RE: DENYING AN APPEAL (AP23- 002) AND AFFIRMING THE PLANNING COMMISSION'S APRIL 11, 2023 ACTION APPROVING AN ENVIRONMENTAL AND DESIGN REVIEW PERMIT (ED22-016) FOR A NEW MIXED-USE BUILDING WITH 162 RESIDENTIAL UNITS AND 8,900 SQUARE FEET OF GROUND FLOOR COMMERCIAL SPACE LOCATED AT 1515 4TH STREET AND DETERMINING THE PROJECT EXEMPT FROM THE CALIFORNIA ENVIRONMENTAL QUALITY ACT PURSUANT TO CEQA GUIDELINES SECTION 15332

1515 FOURTH STREET ASSOCIATES, LLC (the Applicant) is writing in response to the Appeal (AP23- 002) filed by Vikram Seshadri regarding the April 11th Planning Commission approval of the 1515 4th Street Project (the Project). The appeal fails to raise any significant, quantifiable, direct, and unavoidable impacts of the project, based on objective, identified written public health or safety standards, policies, or conditions as they existed on the date the application was deemed complete as required by the Housing Accountability Act (Government Code Section 65589.5). Accordingly, the Appeal has no merit and the Applicant requests that the City Council deny the Appeal.

**1515 4th Street - AMG Traffic Appeal Letter
Of Response**

1515 4th Street - AMG Traffic Peer Review

P

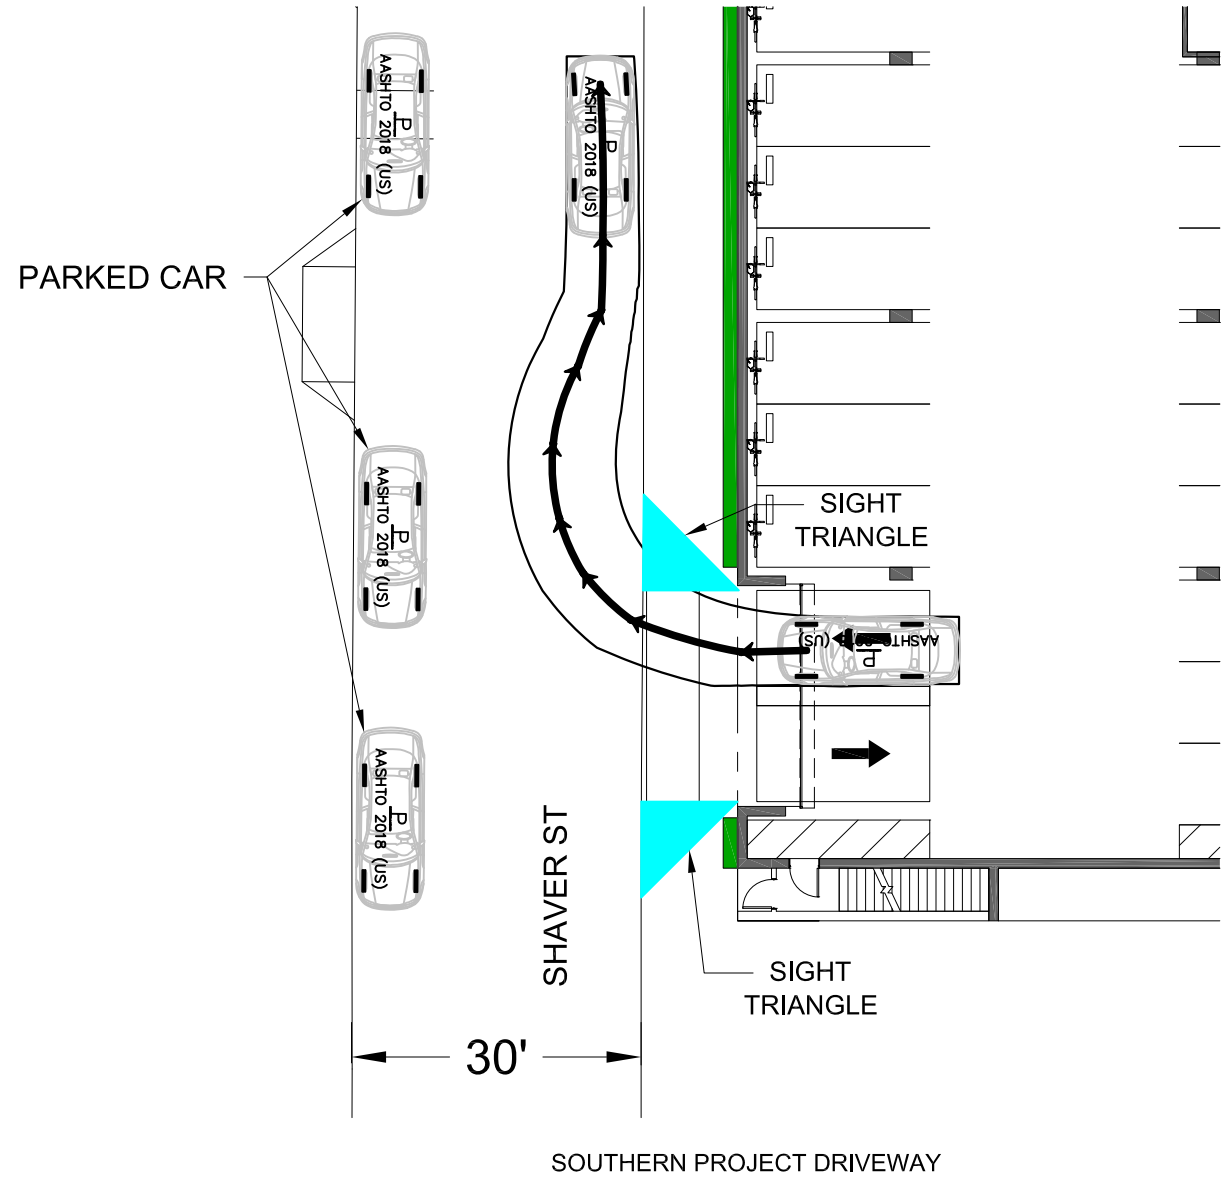
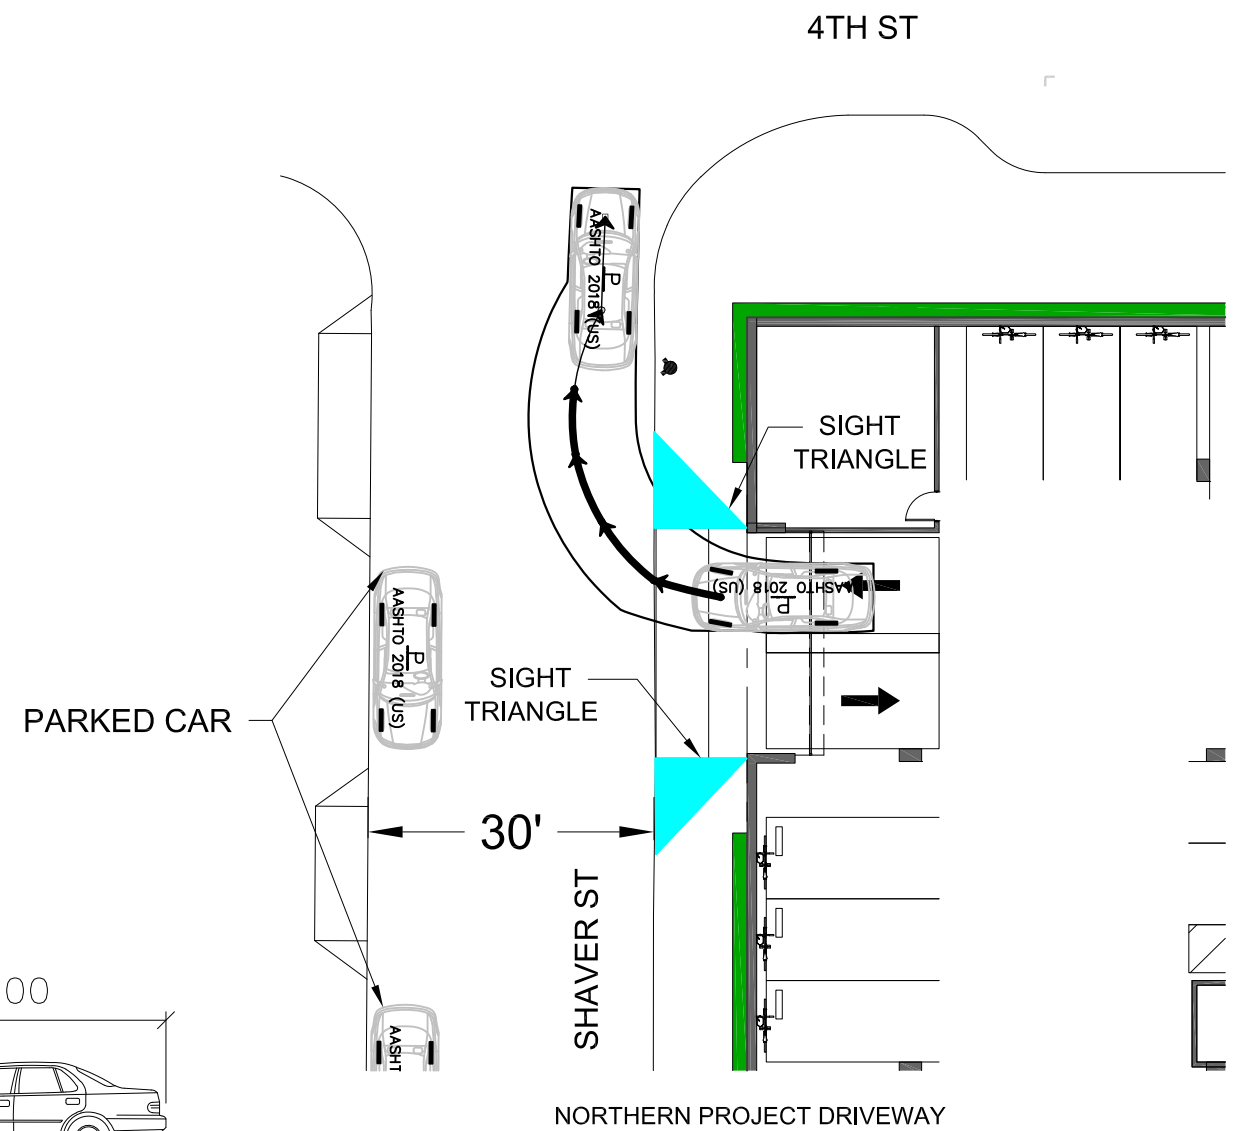
AMG properly analyzed internal circulation within the parking garage. No vehicles larger than a single unit car will be allowed in the parking garage. As indicated in the LTA report, entrance and exit of vehicles will be adequate. In addition to the report, AMG prepared turning radii diagrams to show that circulation and entrance within the parking garage is adequate. The diagrams are included as an appendix to this letter.

Sheet 1 shows the turning radius movements of a passenger vehicle entering the project driveways by making a left turn.

Sheet 2 shows the turning radius movements of a passenger vehicle entering the project driveways by making a right turn.

Sheet 3 shows the turning radius movements of a passenger vehicle exiting the project driveways by making a left turn. The driveway sight triangle is also depicted in this sheet per San Rafael Municipal Code Guidelines.

Sheet 4 shows the turning radius movements of a passenger vehicle exiting the project driveways by making a right turn. The driveway sight triangle is also depicted in this sheet per San Rafael Municipal Code Guidelines.

Proposed Structure at 1515 Fourth St. in Context with Surrounding Buildings

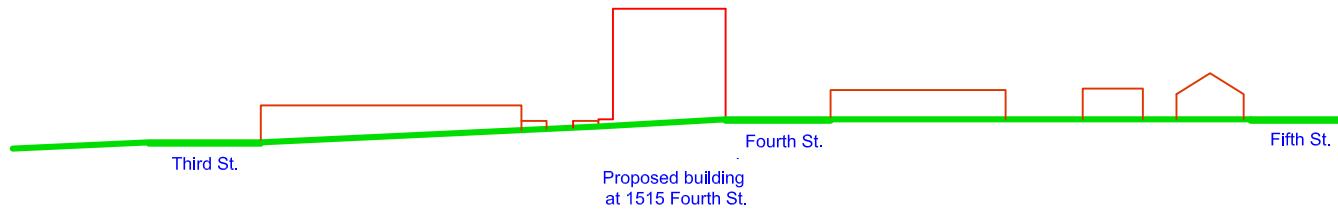
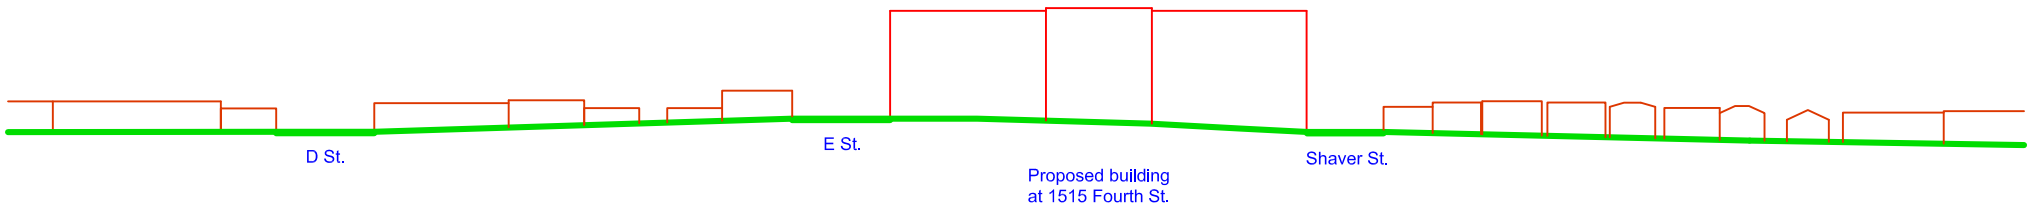
I feel that the drawings provided by the developer were intentionally misleading regarding the relationship between the surrounding buildings and the proposed structure. The perspective drawings were done in such a way that makes the new building look just a bit bigger, but are not truly representative of the vast difference in scale. I've done some basic street elevations that show this more accurately ..
